Title - Sujet WRI office fitup project	
Solicitation No. - N° de l'invitation E62ZR-212805/A	Amendment No. - N° modif. 006
Client Reference No. - N° de référence du client 20212805	Date 2021-10-15
GETS Reference No. - N° de référence de SEAG PW-\$\$HN-331-80357	
File No. - N° de dossier hn331.E62ZR-212805	CCC No./N° CCC - FMS No./N° VME
Solicitation Closes - L'invitation prend fin at - à 02:00 PM Eastern Standard Time EST on - le 2021-11-12 Heure Normale du l'Est HNE	
F.O.B. - F.A.B. Plant-Usine: <input type="checkbox"/> Destination: <input checked="" type="checkbox"/> Other-Autre: <input type="checkbox"/>	
Address Enquiries to: - Adresser toutes questions à: Turner, Louie	Buyer Id - Id de l'acheteur hn331
Telephone No. - N° de téléphone (613) 297-3769 ()	FAX No. - N° de FAX () -
Destination - of Goods, Services, and Construction: Destination - des biens, services et construction:

Solicitation amendment 006 is issued to answer potential bidders and site visit questions and to extend the bid closing date to November 12, 2021.

LOADING DOCK & FREIGHT AREA

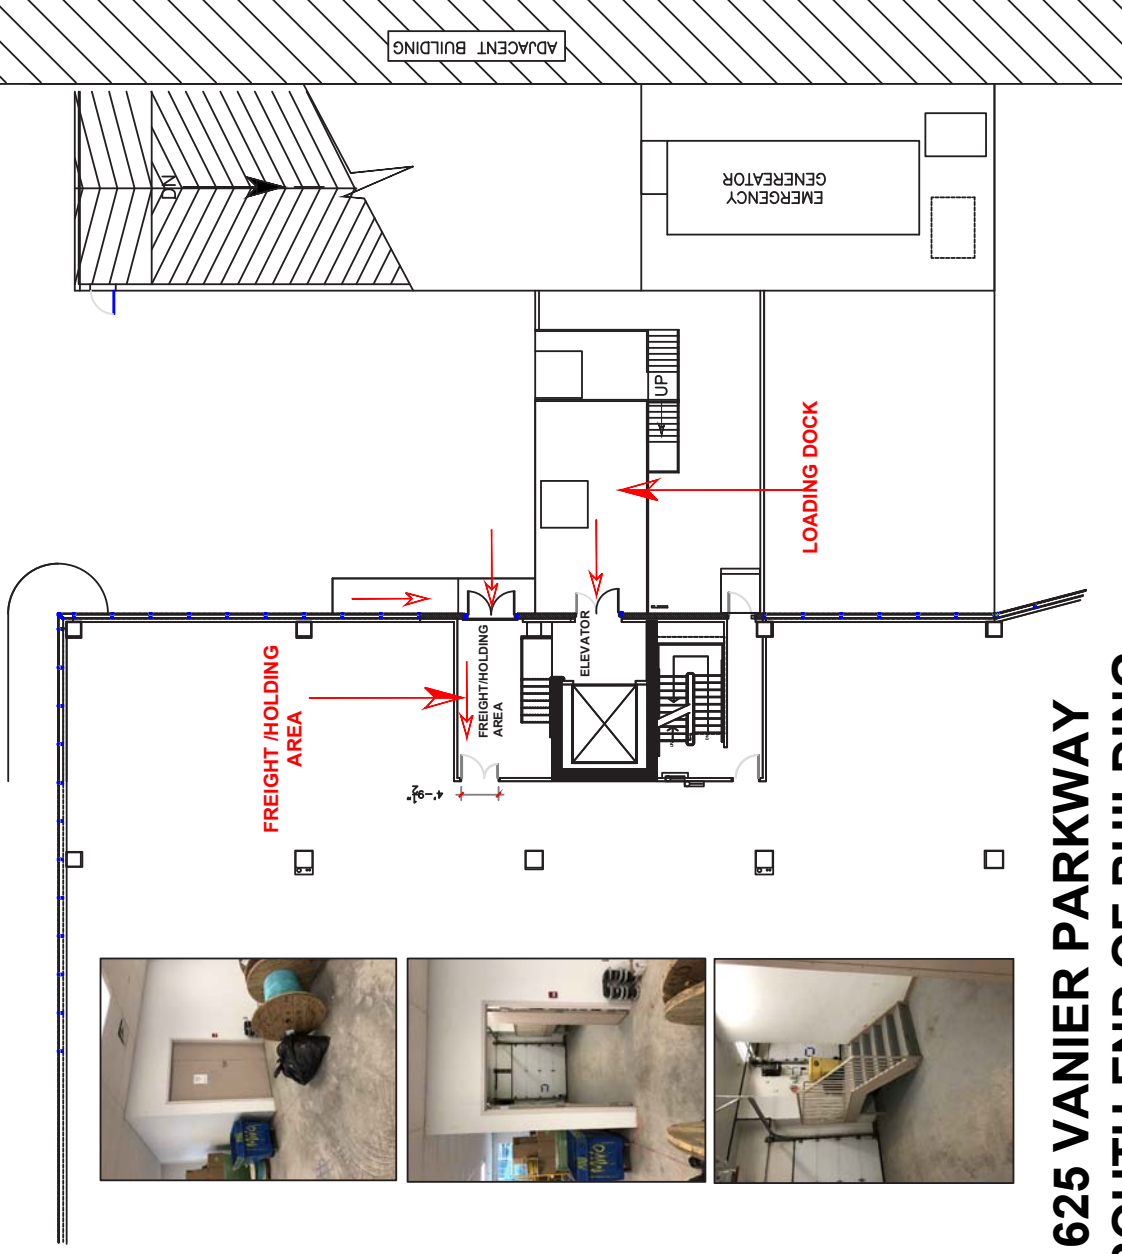
Can we get pictures of the loading dock and freight elevator access.

Are there any truck restrictions for deliveries?

See attached picture/drawing

Please refer to loading doc picture.
